In Support D1.3 Comments

IEEE 802.3bj Task Force

Ali Ghiasi –Broadcom
Will Bliss - Broadcom

Jan 23-24, 2013

TP0a/TP5a Return Loss

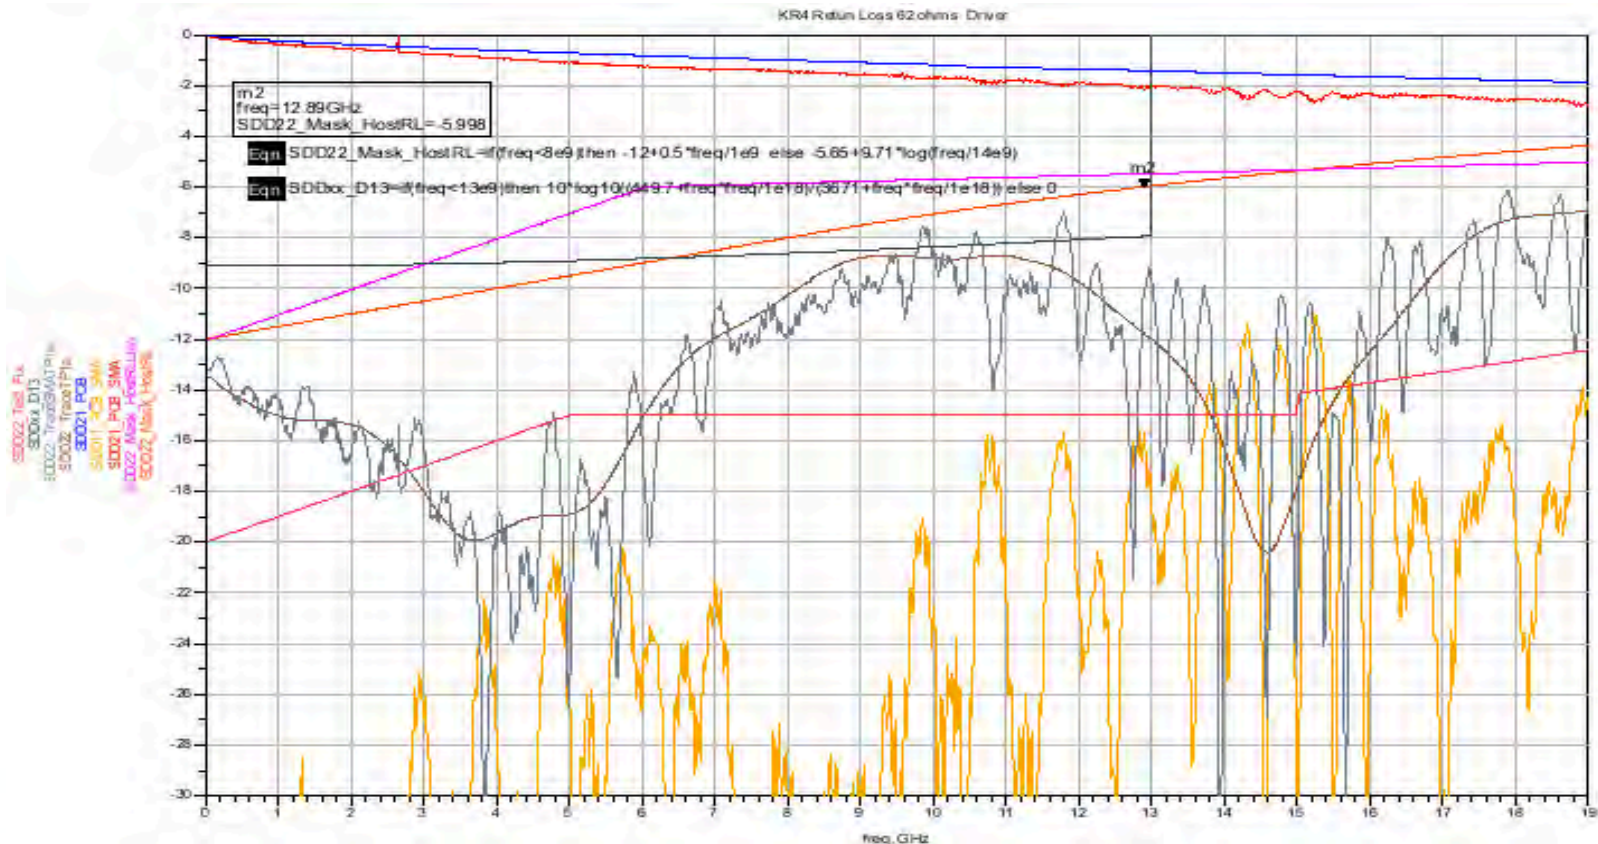
- Return loss for 62 Ω driver shown at output of the stripline as well as at output of SMP 6" cable
 - Also shown is proposed masked proposed during adhoc meeting (Blue) that could result failing CR4 TP2 RL
 - Proposed mask (red) identical to eq 92-5 addressing comment 128/129/132/134

TP0a/TP5a Return Loss

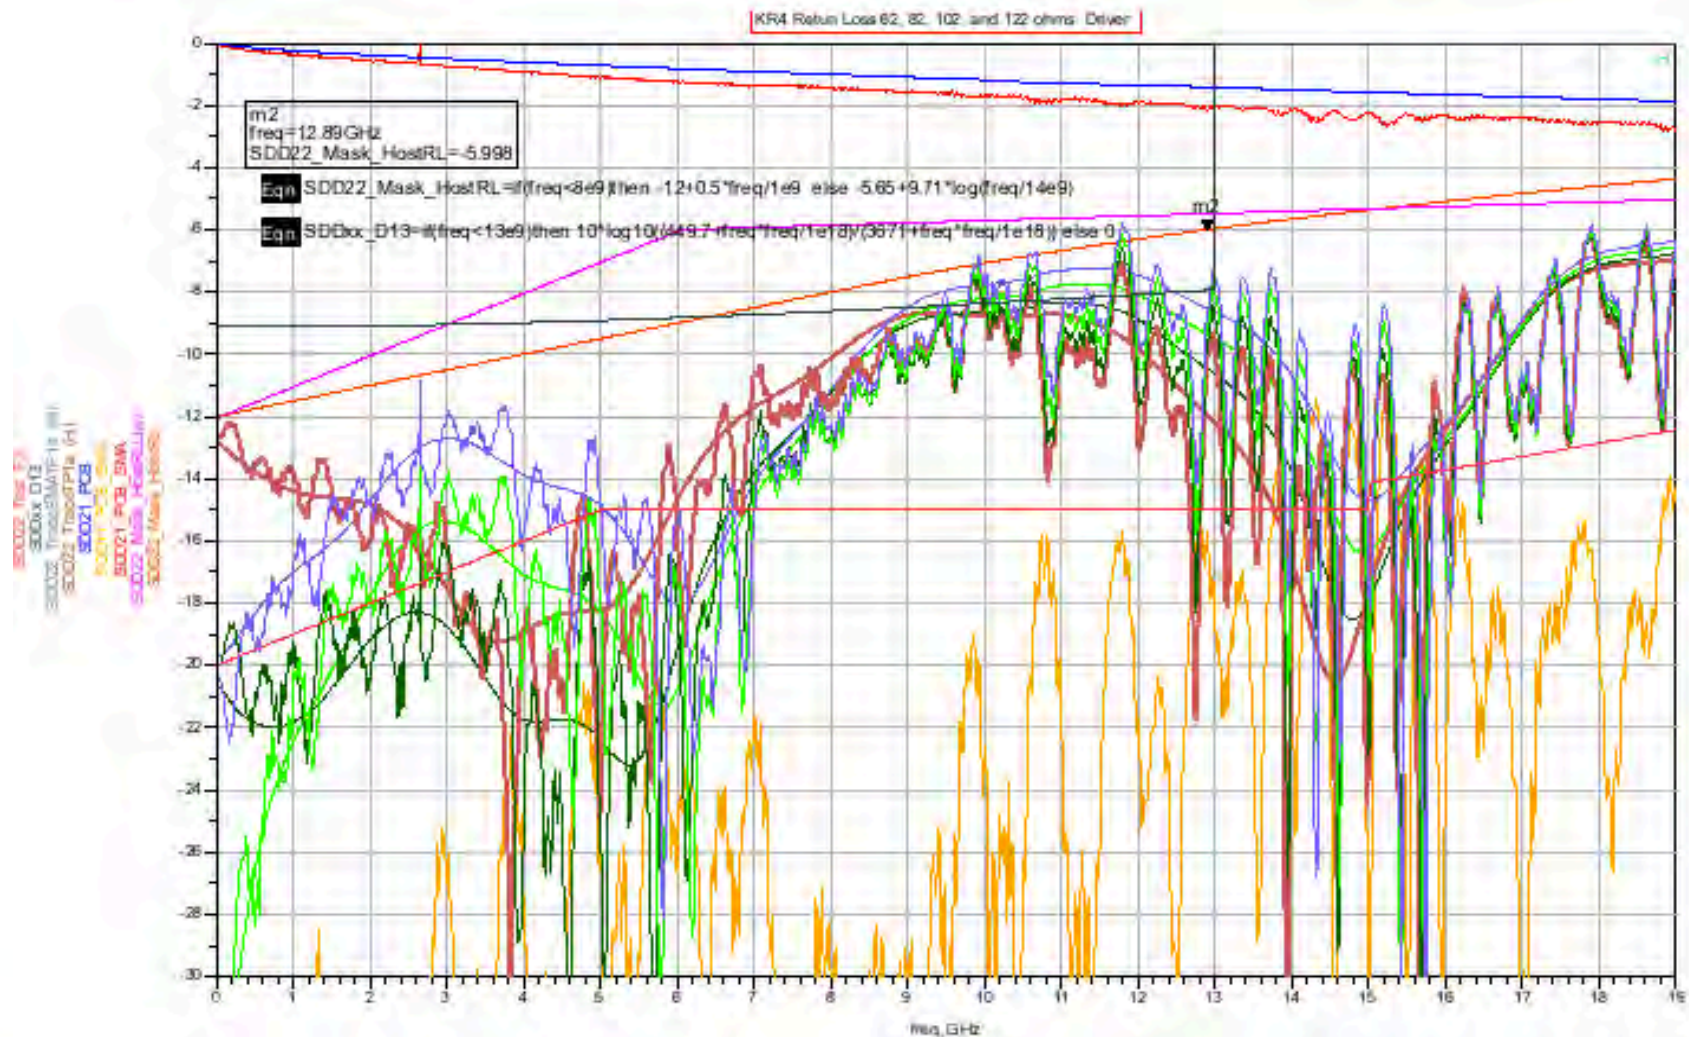
- Return loss from 62 -122 Ω driver in 10 Ω steps
 - Worst RL for 122 ohms driver

Transmitter and Receiver Differential Host Board Loss

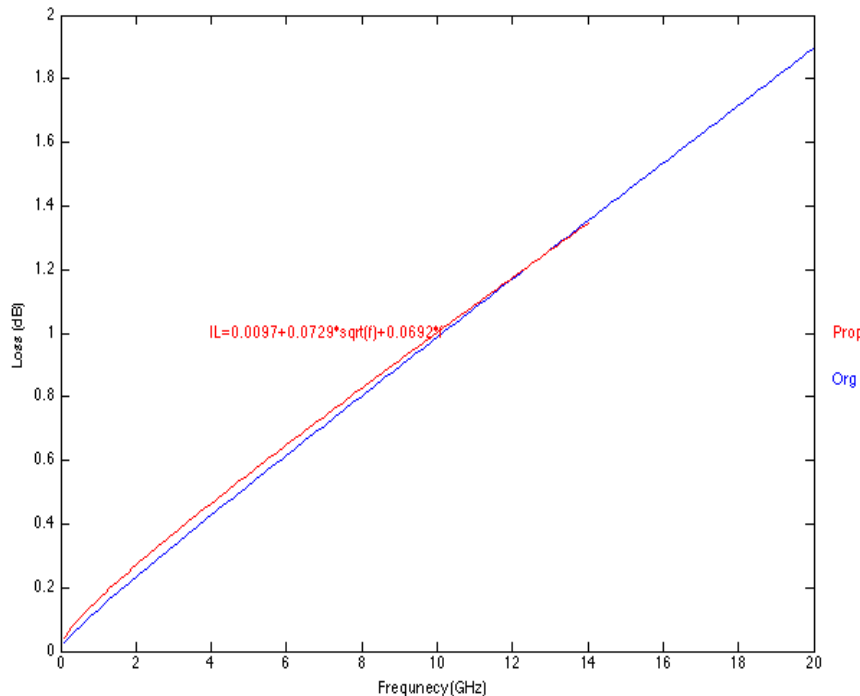
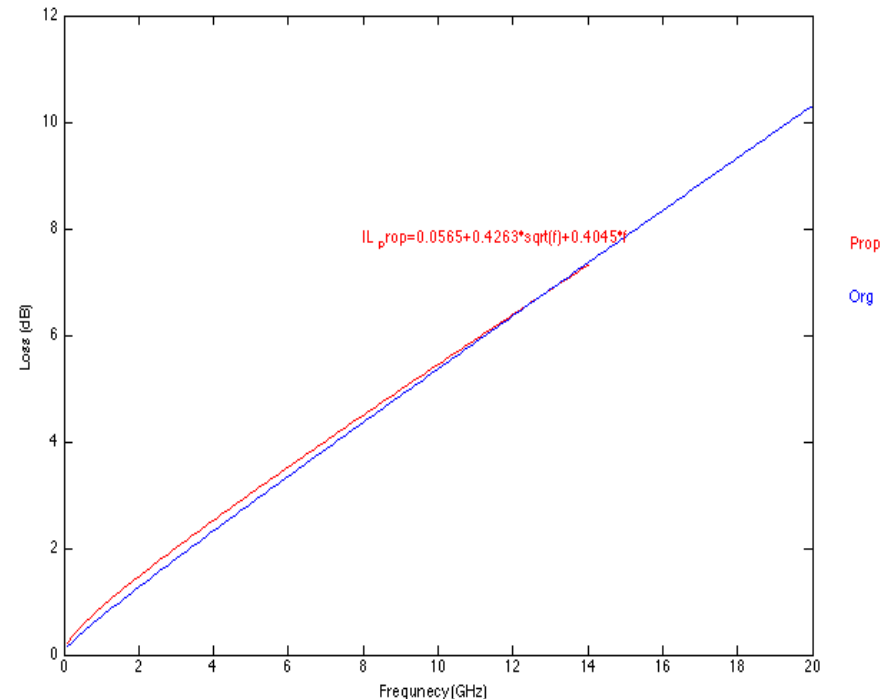
- Addressing comment 130
 - Current differential PCB loss is not consistent with the channel TP0-TP2 or TP3-TP5
 - Equation 92A-1 and 92A-2 linear term is >2x the sqrt term
 - But the channel loss Eq 92-4 linear term ~ as the sqrt term

Standalone KP4 Sinusoidal Jitter Test

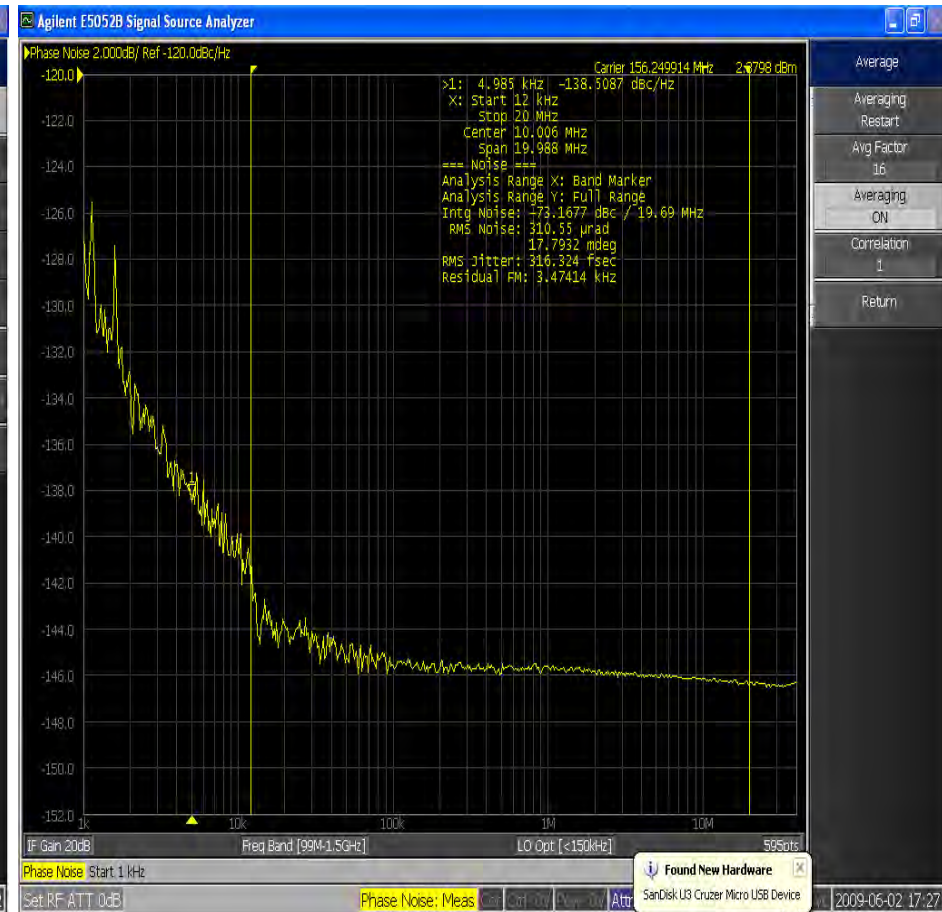
- Other standards such as 10Gbase-LRM, 40Gbase-CR4/KR4, 16G FC have used standalone Sinusoidal Jitter test to the receiver to make sure clock jitter allowed by transmitter is trackball by the receiver
 - Separate interference tolerance based on worst case channel will test the receiver equalization capability
 - Adding SJ to the above test will be too complex
- Since time of 10 GbE the loop BW for golden CDR to track allowed jitter by the transmitter has been $F_{\text{baud}}/2500$
 - This was reasonable loop BW for days when good oscillators were costly and the receiver was simple Bang-Bang CDR
 - KP4 having more complex receiver and with availability of low cost good performance oscillator the golden CDR BW should be reduced to $F_{\text{baud}}/33,985$
- Addressing comment 133/140

Diagram of SJ Tolerance Mask

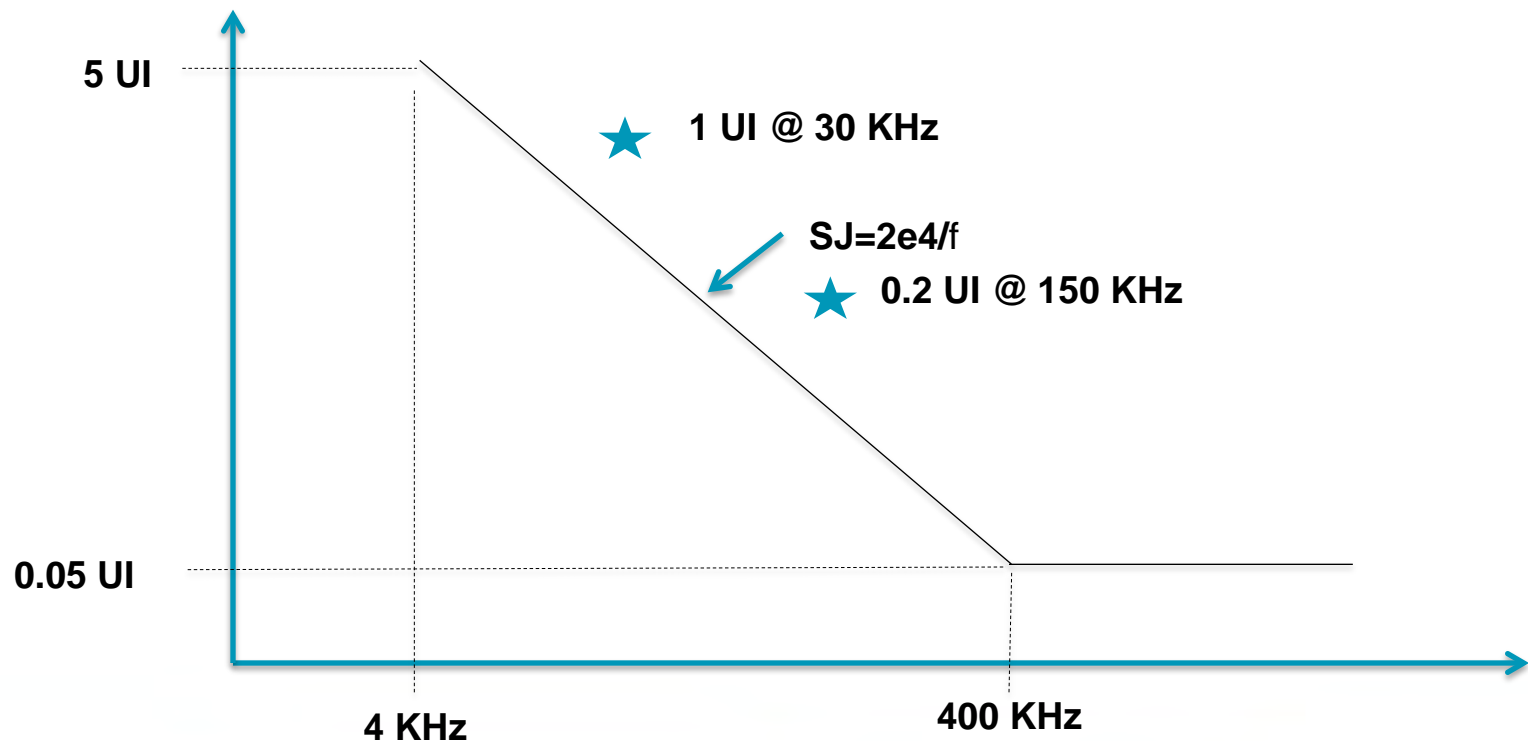
- KP4 transmitter is tested with golden CDR having loop BW of $F_{\text{bud}}/33985$
 - KP4 receiver is tested at about 2x the mask amplitude $2e4/f$
 - 1 UI @ 30 KHz
 - 0.2 UI @ 150 KHz

KP4 SJ Test Setup

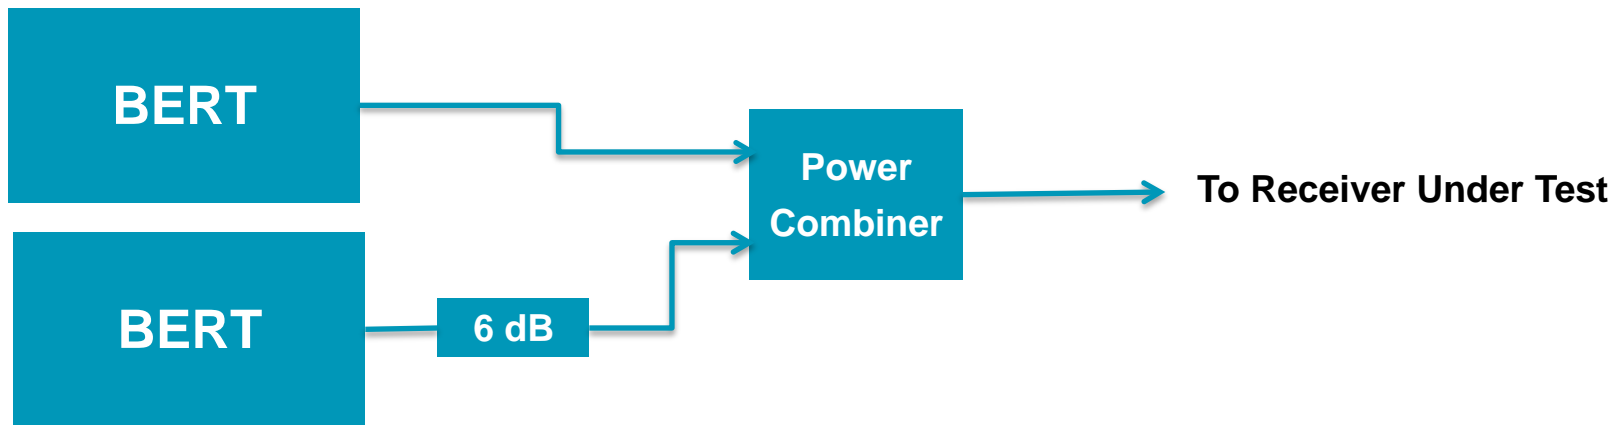
- Pattern PN31
- SJ applied 1 UI @ 30 KHz and 0.2 UI @ 150 KHz
- Output waveform should be tested at max and min amplitude limits
- BER $1E-5$
